ADDENDUM NO. 4

Reference: Holland Centennial Commons
Dixie State College – St. George, Utah
DFCM Project No. 06297640

ADDENDUM No. 5

**Dixie State College of Utah
Holland Centennial Commons
Addendum #5
Civil Drawings and Specifications**

HOLLAND CENTENNIAL COMMONS
 ADDENDUM #5
 SHEET C102

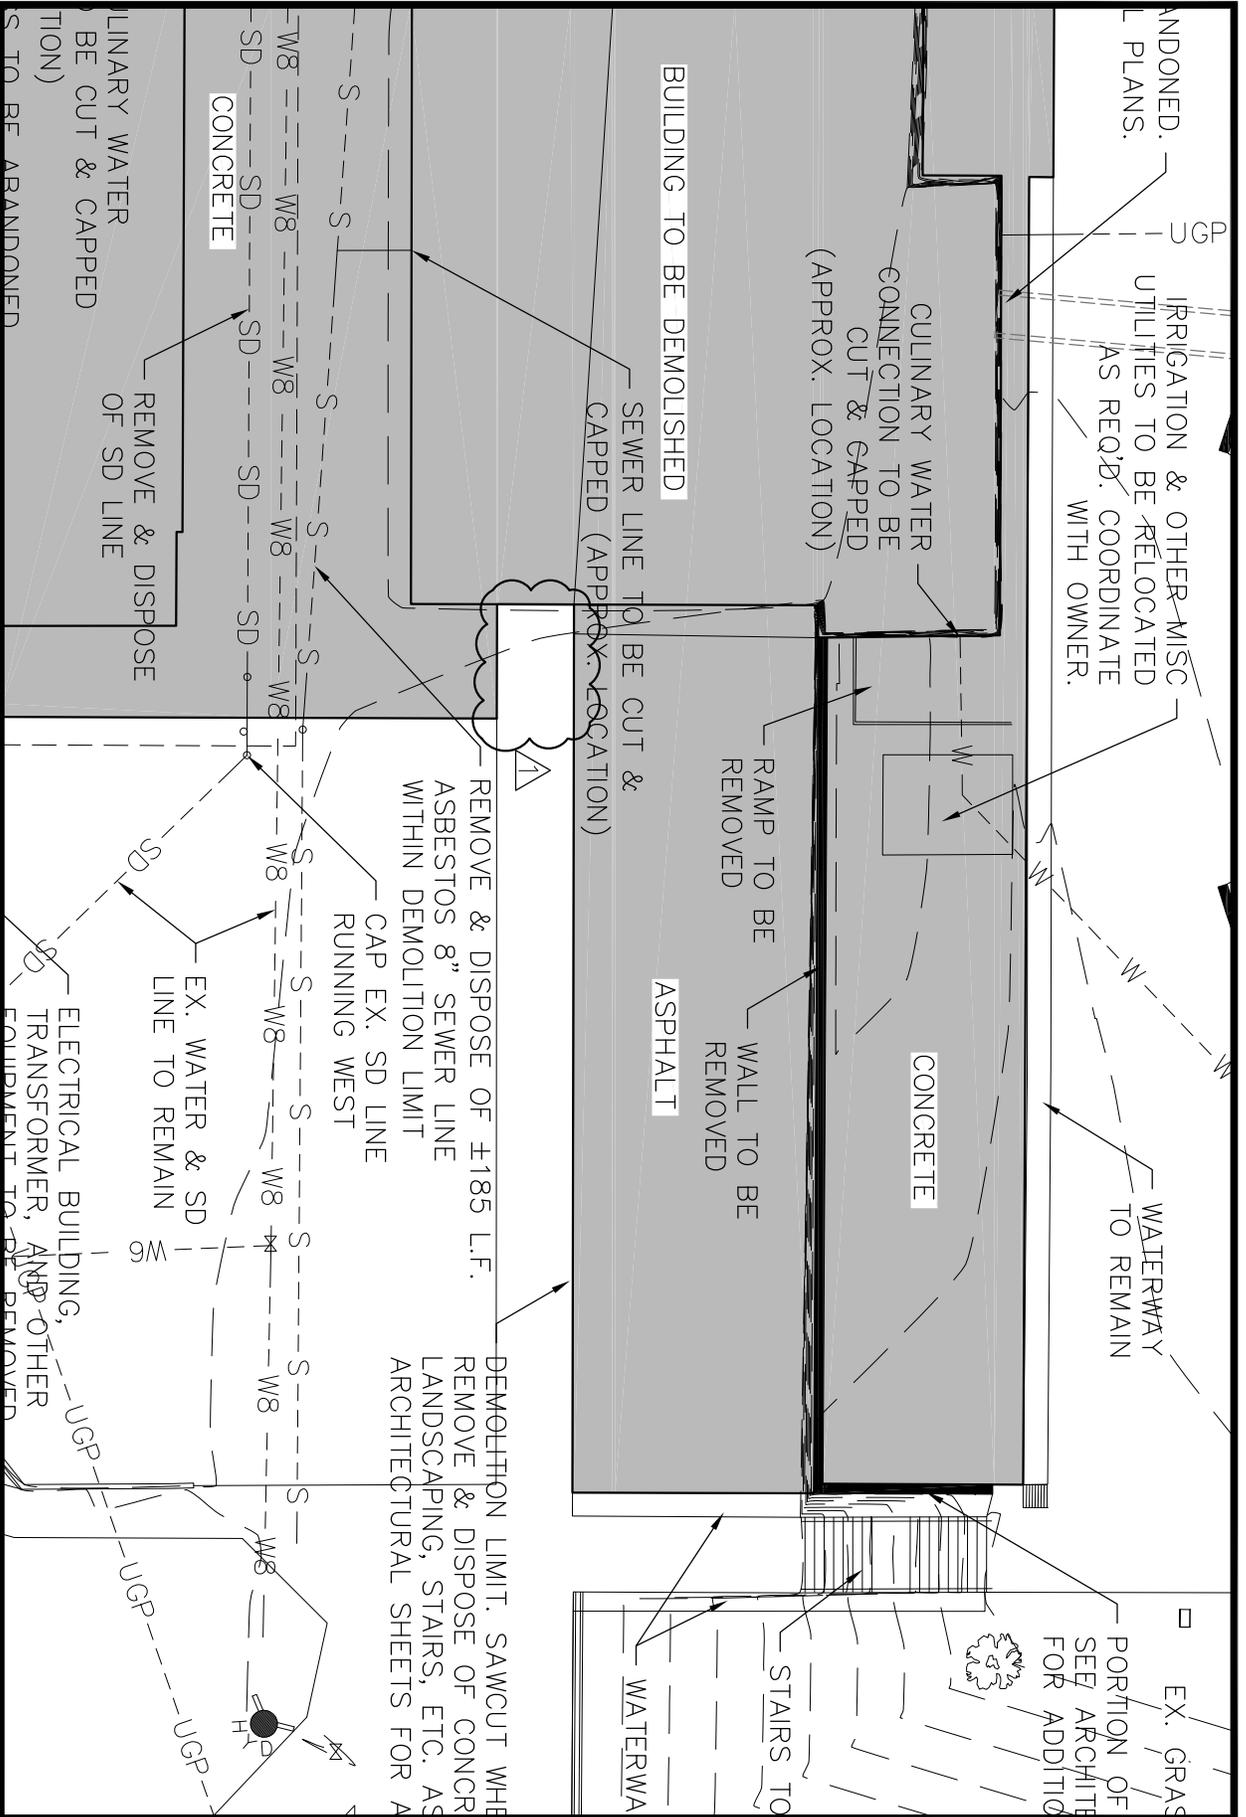
4. Demolition limits around the Whitehead Building and Career Center have been modified. See sheets AD5-6 and AD5-7 of this addendum.

AD5-7
 MODIFIED DEMOLITION LIMIT & SAWCUT LINE.

SHEET C104

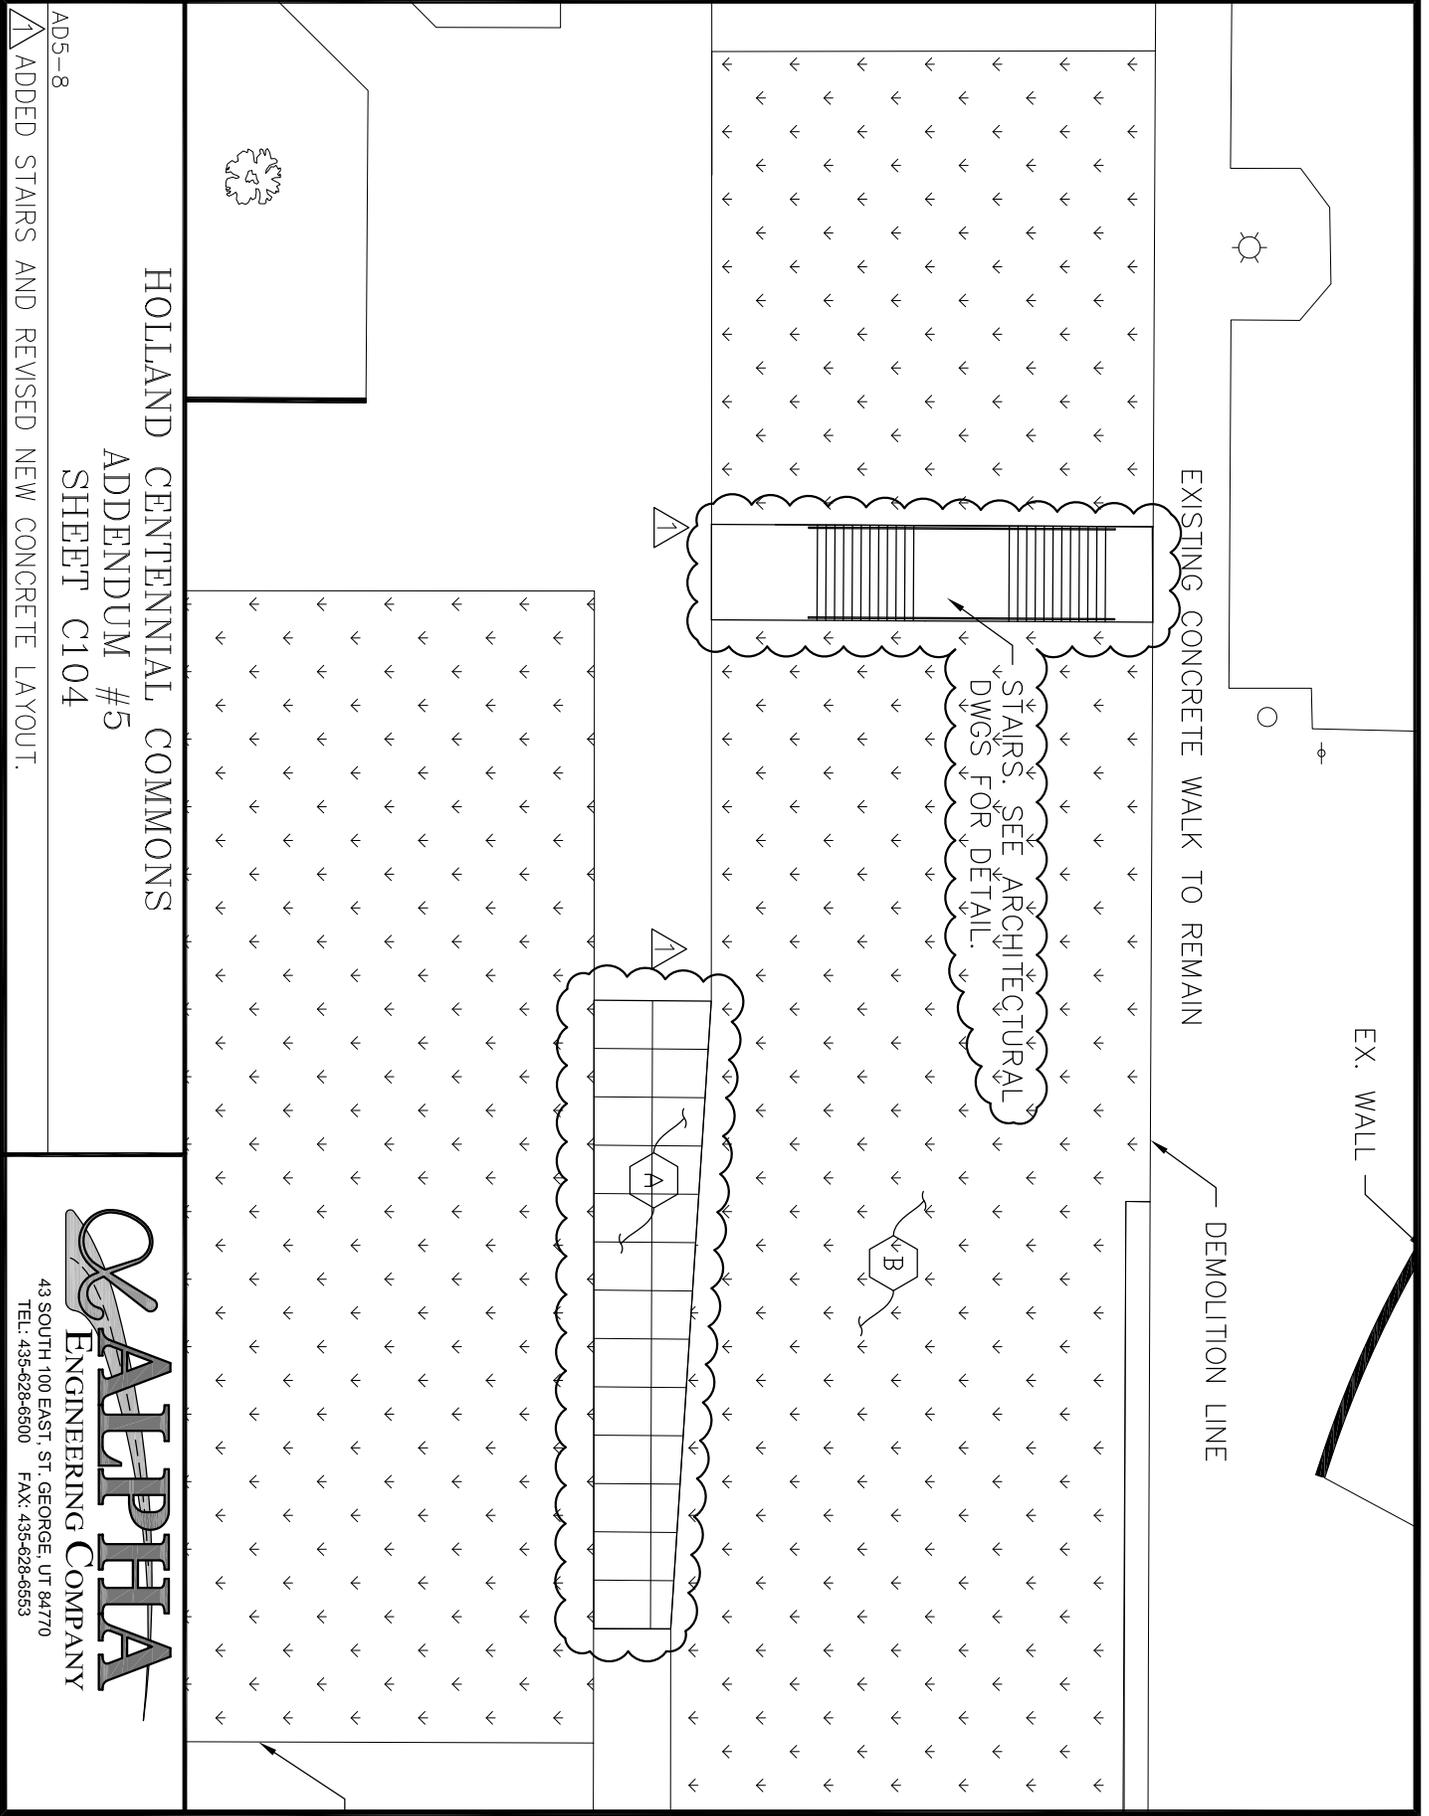
6. New stairs have been added west of the demolished Career Center. In addition, the new sidewalk has been modified in this area for the new demolition limits per Item #4 of this addendum. See sheet AD5-8 of this addendum.

AD5-8
ADDED STAIRS AND REVISED NEW CONCRETE LAYOUT.

SHEET C302

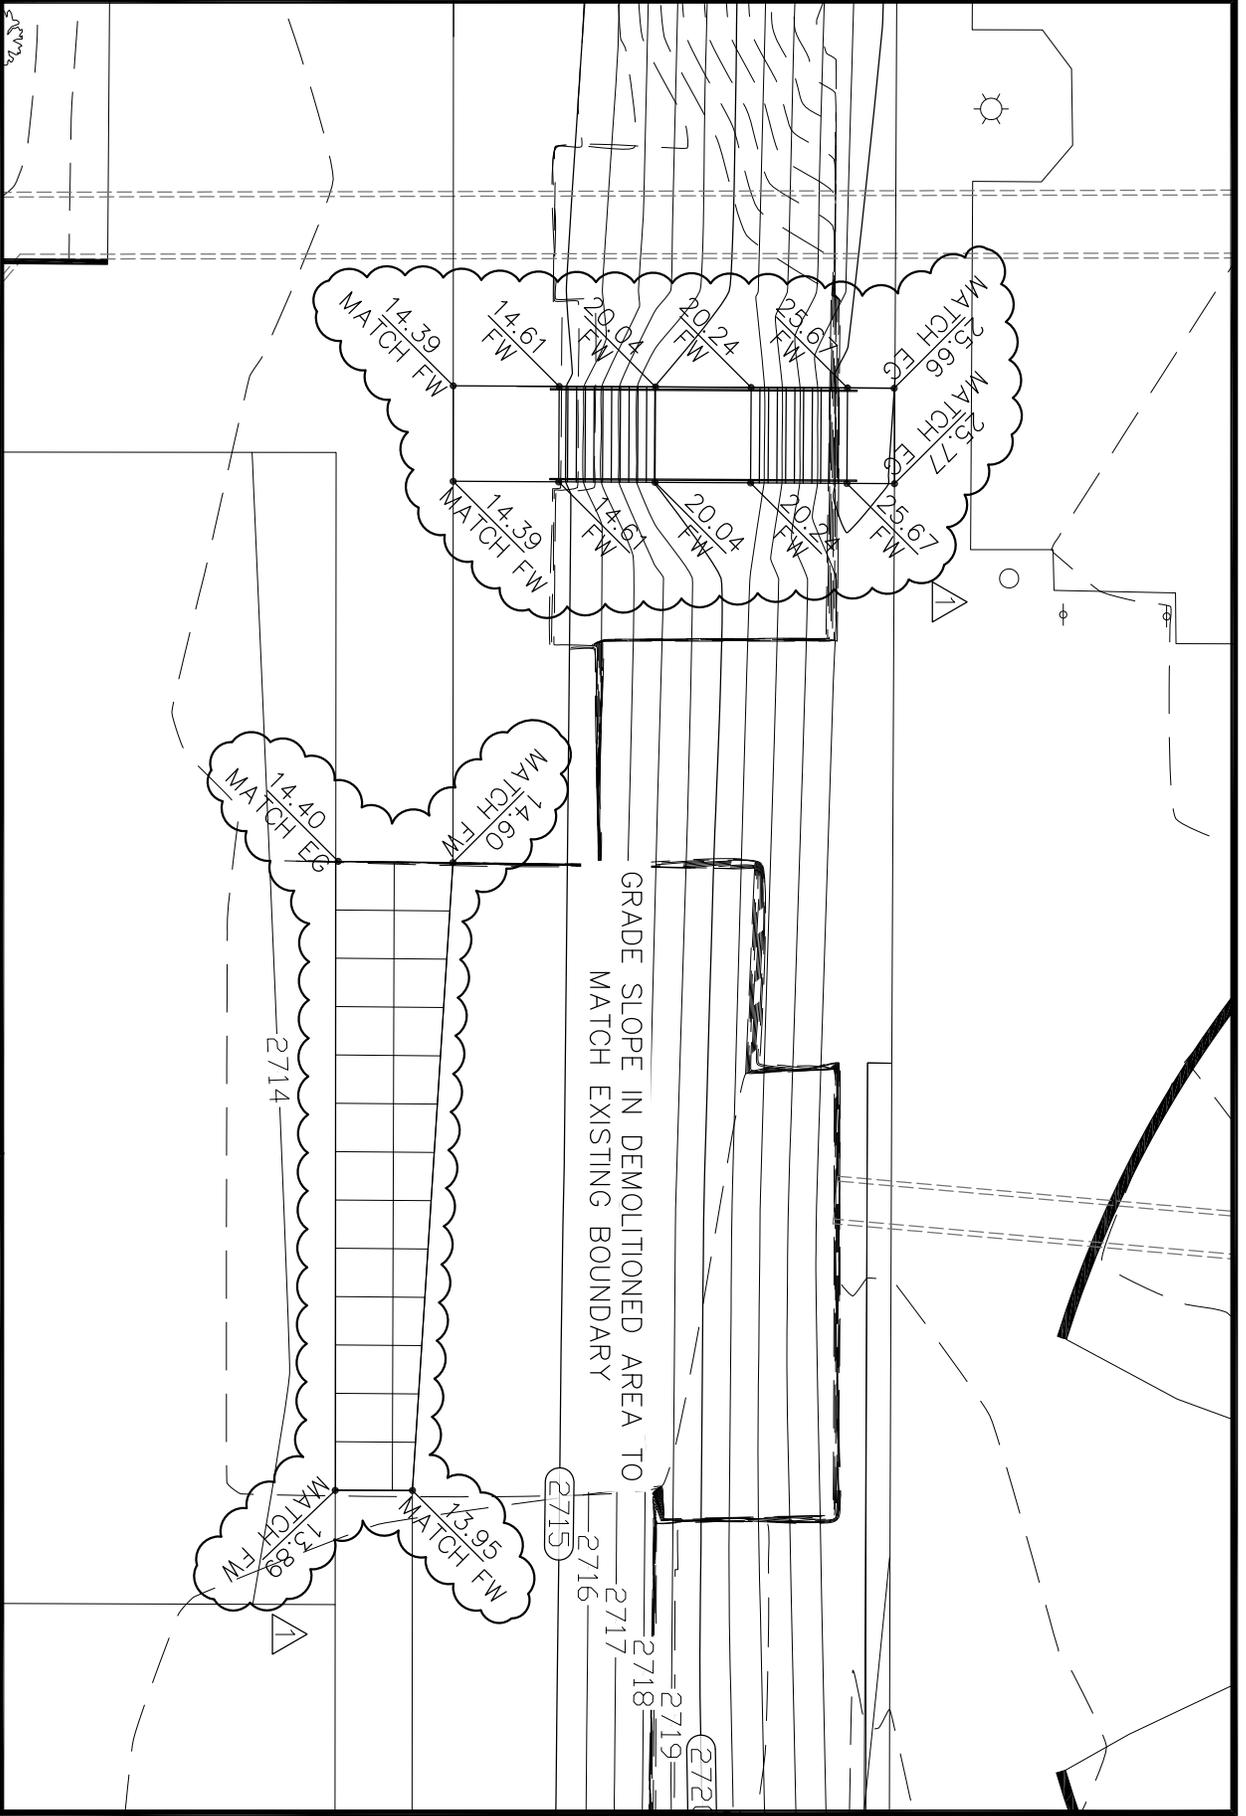
8. Additional grading for the relocated transformer at the Central Plant has been added. See sheet AD5-9 of this addendum.
9. The grading has been revised for the modification of the new sidewalk and to specify grades for the new stairs per Item #6 of this addendum. See sheet AD5-10 of this addendum.

ADDED GRADING TO NEW STAIRS & MODIFIED GRADING PER NEW CONCRETE.

SHEET C503

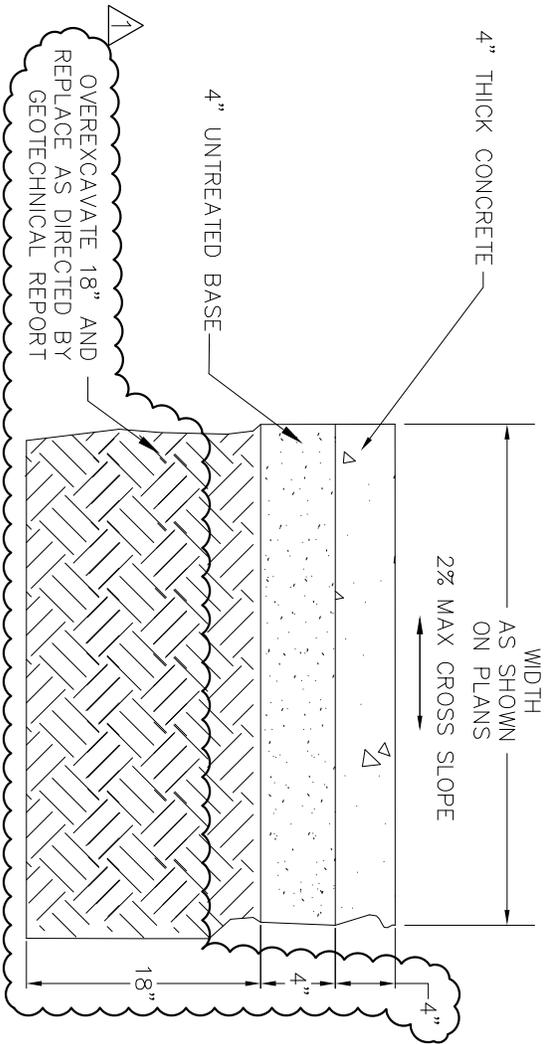
11. The detail for the sidewalk has been modified to include overexcavation for the sidewalk. See sheet AD5-11 of this addendum.

REVISD ON-SITE CONCRETE SIDEWALK DETAIL.

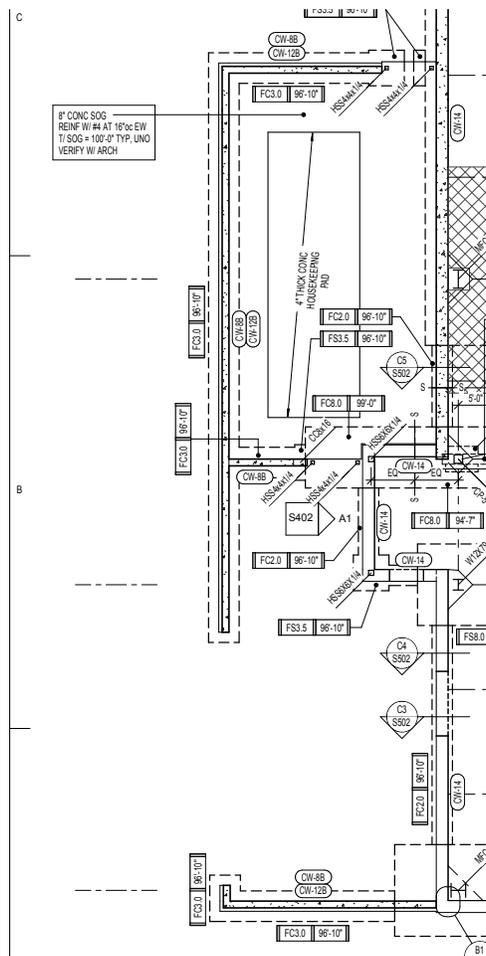
Sheet	Item	Description
S111	1	The screen wall footings running north south, to the west of Grid 1 and between D.3 and F.2, should be FC3.0 (not FC2.0). See below
	2	The screen wall footing running east west, on Grid D.3 and just west of Grid 1, should be FC3.0 (not FC2.0). See below

ADD
MH1.03

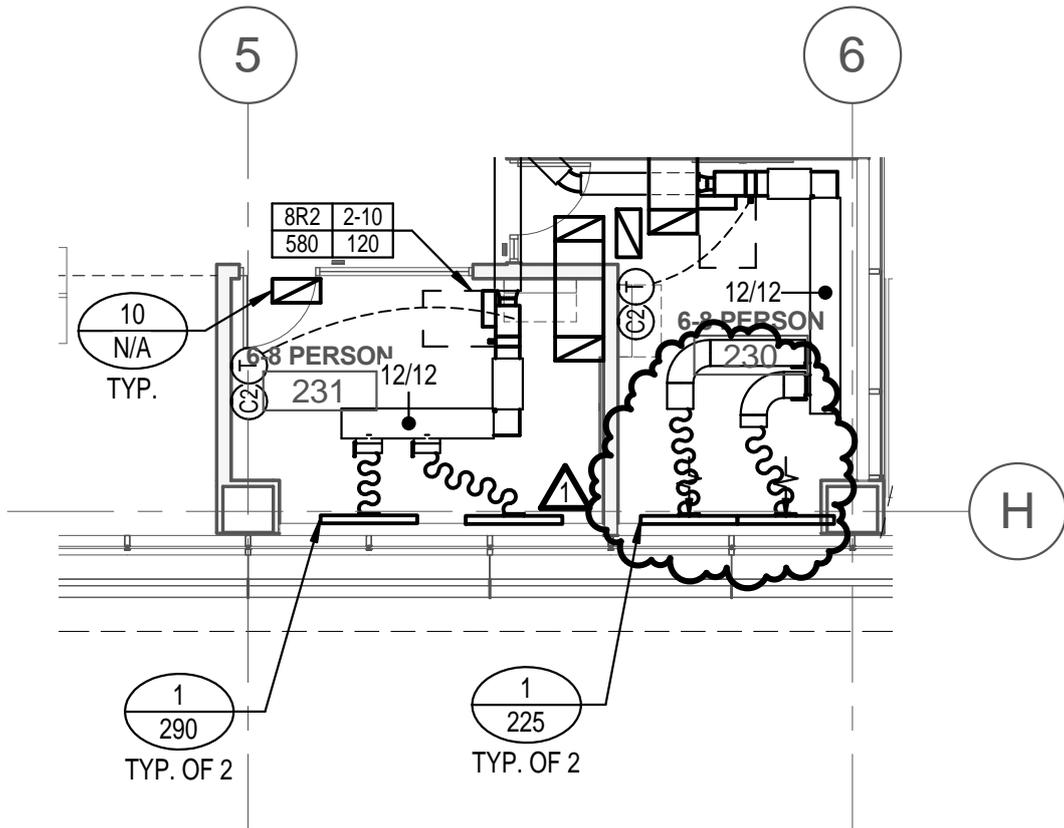
ADDENDUM #5
RELOCATE THERMOSTAT AND CO2 SENSOR

ADD
MH1.02

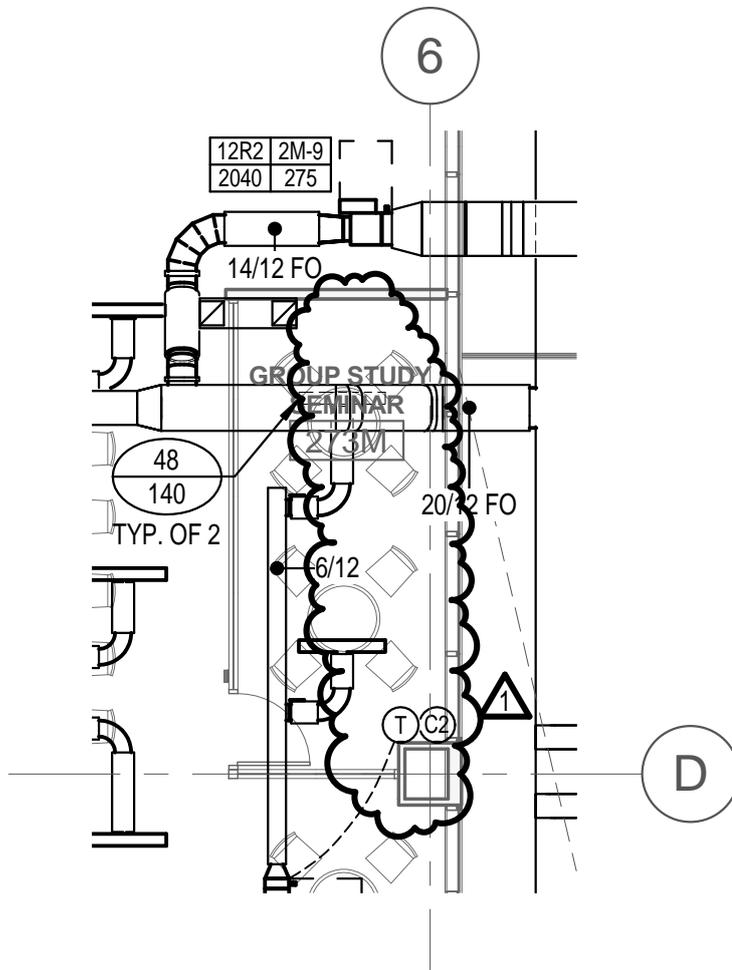
ADDENDUM #5
SLOT DIFFUSERS RELOCATION
